**STAFF REPORT: 12-11-2019 MEETING**

**APPLICATION NUMBER: 19-6525**

**ADDRESS: 2475 CHICAGO**

**SCOPE: DEMOLISHED REAR PORCH, ERECTION OF NEW PORCH**

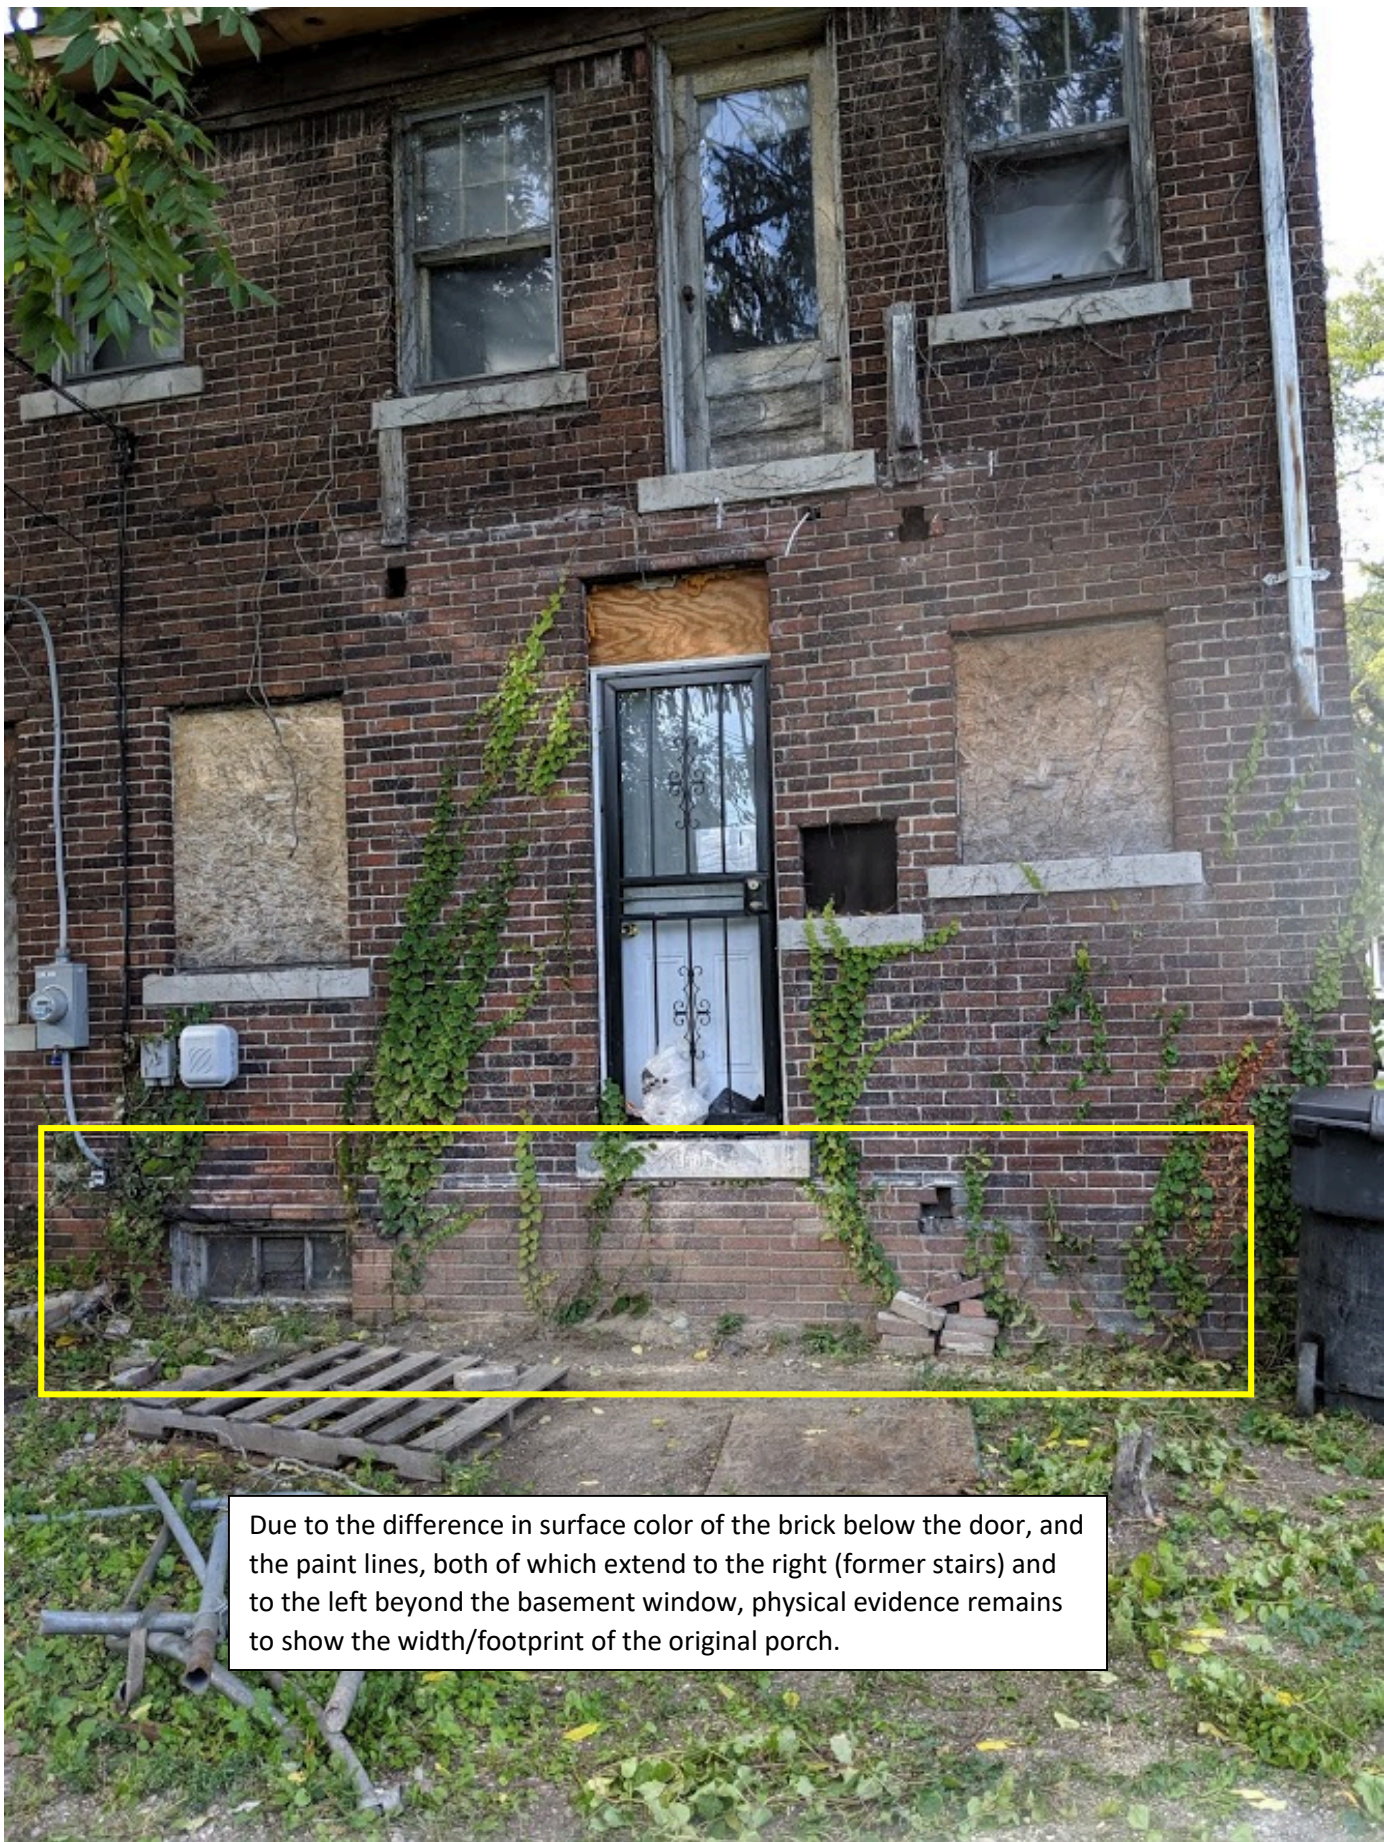
Due to the difference in surface color of the brick below the door, and the paint lines, both of which extend to the right (former stairs) and to the left beyond the basement window, physical evidence remains to show the width/footprint of the original porch.

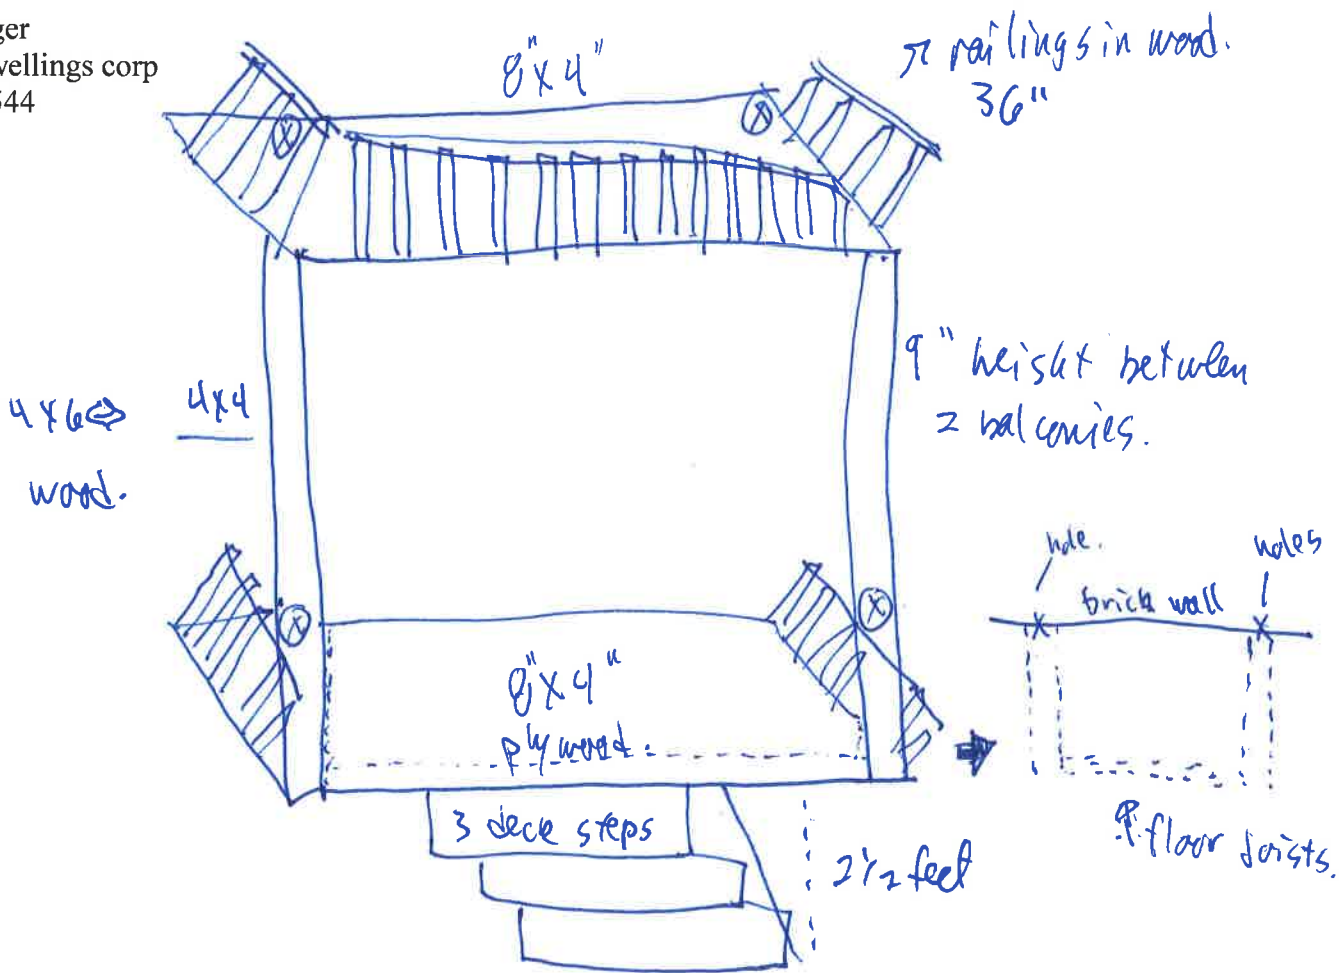
balcony 8' x 4'

10 feet .

2.5 feet from the ground.
